METROPOLITAN GOVERNMENT OF NASHVILLE AND DAVIDSON COUNTY

STAFF RECOMMENDATION
204 S. 11th Street
September 19, 2012

Application: New construction - addition
District: Lockeland Springs-East End Neighborhood Conservation Zoning Overlay
Council District: 06
Map and Parcel Number: 08313001400
Applicant: Preston Quirk, Quirk Designs
Project Lead: Michelle Taylor, michelle.taylor3@nashville.gov

2 FRONT ELEVATION

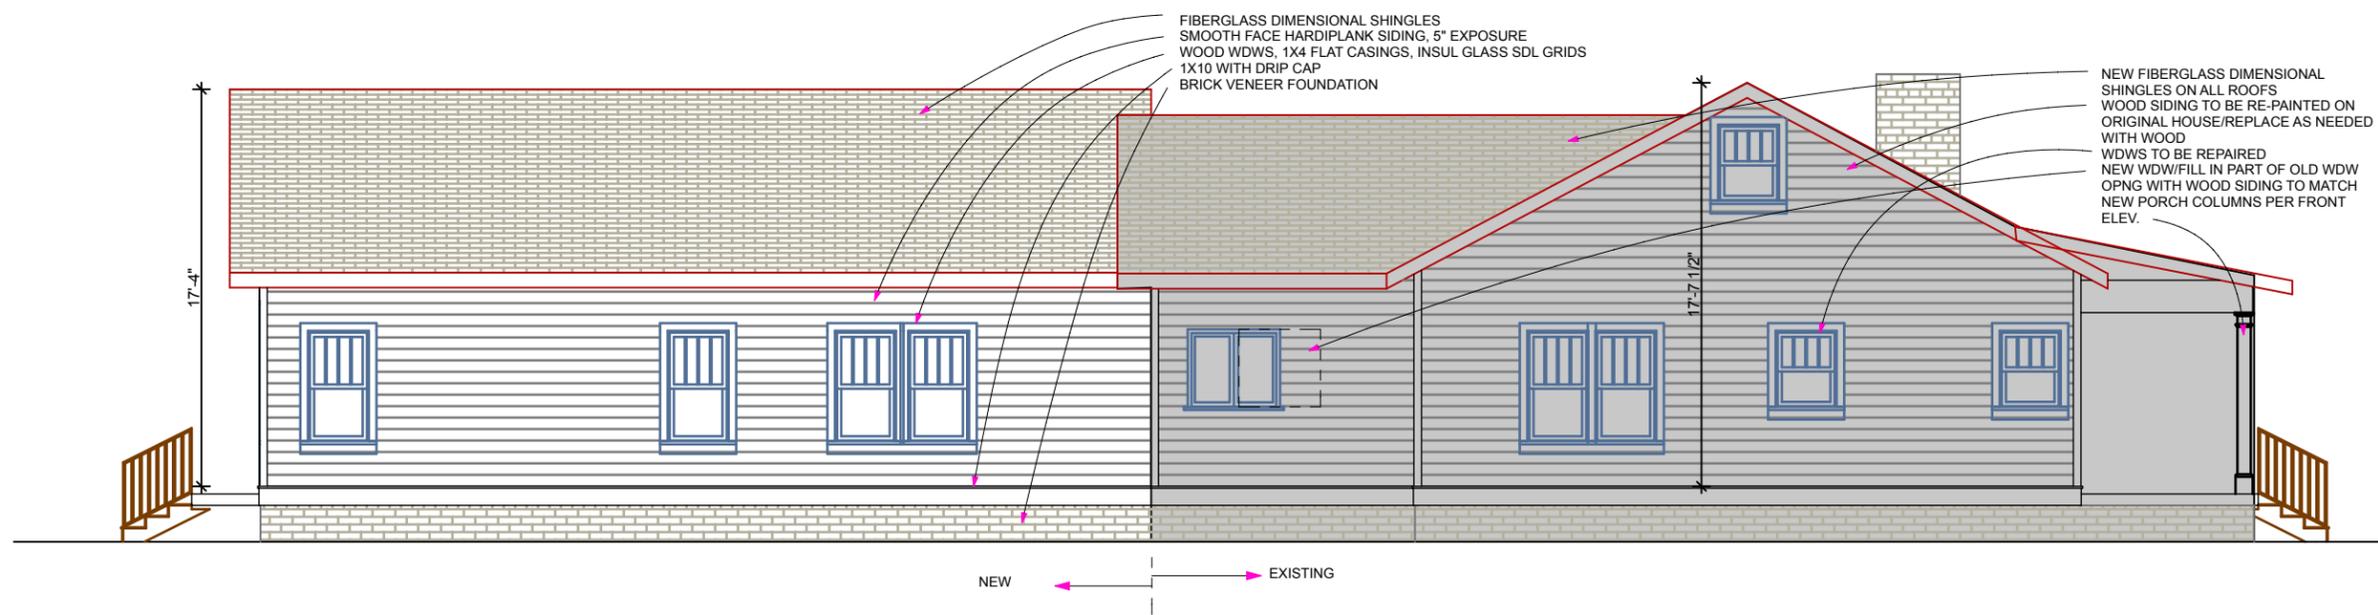
3. Staff review and approve the color of the fiberglass shingle, the window and door specifications and a brick sample prior to purchase and installation; and
4. The applicant remove the lattice between the four paired columns on the front porch and the additional porch post shown on the right elevation.

Staff recommends
removal of lattice
between porch
posts.
